May 22, 2020

Travis Duncan
Sares | Regis
901 Mariners Island Boulevard, Suite 700
San Mateo, CA 94404

Subject: Cityline Subblock 3 South – Avian Collision Risk Assessment (HTH #4439-01)

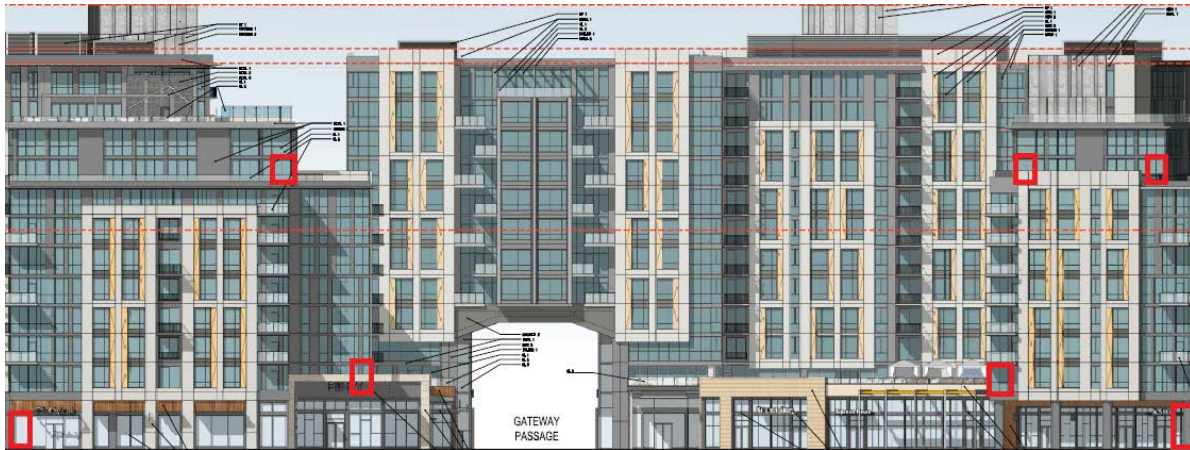
The recommended approximate treatment areas are shown on Figures 3–9; treatment should extend as far from each building corner as it is possible to see through to the other side of the building.

Figure 3. The south facades of Buildings 1 and 2 as seen from McKinley Street. Transparent glass corners that are located along potential flight paths for birds, and hence represent potential collision hazards, are shown in red. In our opinion, these areas should be treated with a bird-safe glazing treatment to comply with the City's guidelines.

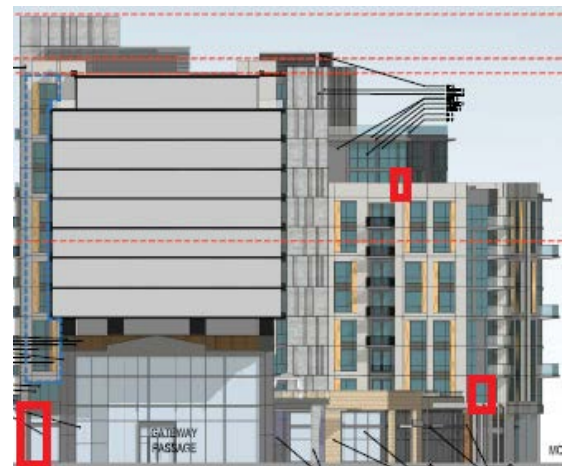
Figure 7. The west facade of Building 2 as seen from the public plaza. Transparent glass corners that are located along potential flight paths for birds, and hence represent potential collision hazards, are shown in red. In our opinion, these areas should be treated with a bird-safe glazing treatment to comply with the City's guidelines.

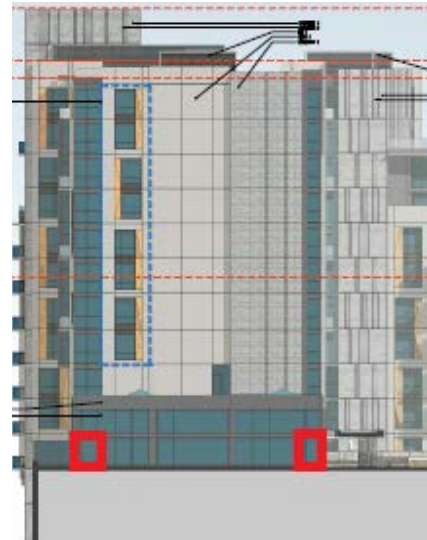
Figure 8. The west façade of Building 2. Transparent glass corners that are located along potential flight paths for birds, and hence represent potential collision hazards, are shown in red. In our opinion, these areas should be treated with a bird-safe glazing treatment to comply with the City's guidelines.
